**MODIFICATION REQUEST:
CASUARINA TOWN CENTRE
TWEED COAST ROAD, CASUARINA
06_0258 MOD 7**

Secretary's Environmental Assessment Report
Section 75W of the
Environmental Planning and Assessment Act 1979

June 2014

Figure 4: Retail Centre Layout – Proposed Stage 2

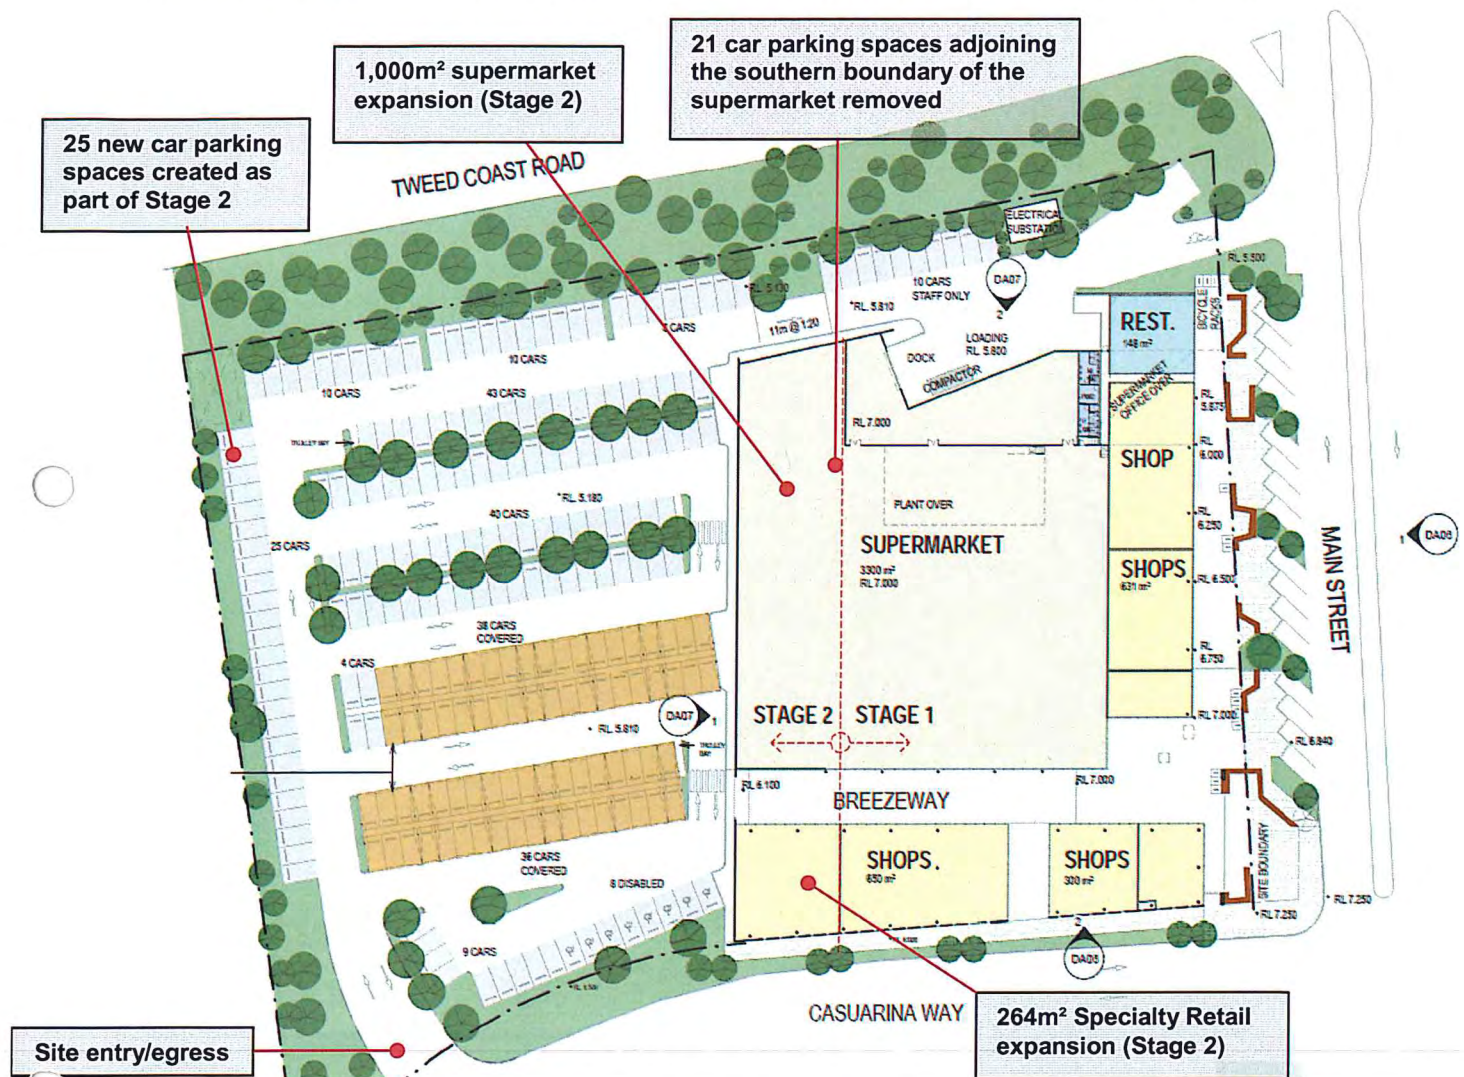
The modification proposes 237 car parking spaces as part of Stage 1. The Stage 2 expansion proposes the removal of 21 existing car parking spaces (including eight disabled car parking spaces) which are proposed adjoining the supermarket's southern boundary. The removal of these car parking spaces will provide space for the proposed 1,000m² expansion of the supermarket (Stage 2). To compensate the loss of these spaces, an additional 25 car parking spaces are proposed to be created adjoining the retail centre's southern site boundary, in a location that will initially be landscaped as part of Stage 1. **Figures 3 and 4** depicts the location of car parking proposed to be removed and created, respectively, as part of Stage 2.

1) The technical memorandum car parking assessment specifies that ten (10) disabled car parks are required for the proposed Casuarina retail centre. The car parking plan "Site Plan and Schedules Stage 2" details only eight (8) disabled car parks provided.

2) The disabled car parks as detailed on the car parking plan do not comply with Australian Standards AS 2890.6 – off street parking for people with disabilities. The disabled car park design used for the shopping centre should only be used for on street car parking.

In regards to the width of disabled car parking spaces, DP&E is satisfied that sufficient space is allocated in the submitted plans and that the detailed design of these spaces can be dealt with at construction certificate stage, which requires approval of the PCA. In addition, DP&E notes that Condition B19 – *Car Parking* requires disabled car parking to be provided in accordance with DCP A2. However, DCP A2 makes reference to a superseded version of AS2890.6 (AS2890.1 is currently referenced). Condition B19 is therefore recommended to be modified to delete the requirement for disabled car parking to be provided in accordance with DCP A2, to be replaced with AS2890.6. Council has indicated support for the recommended amendment.
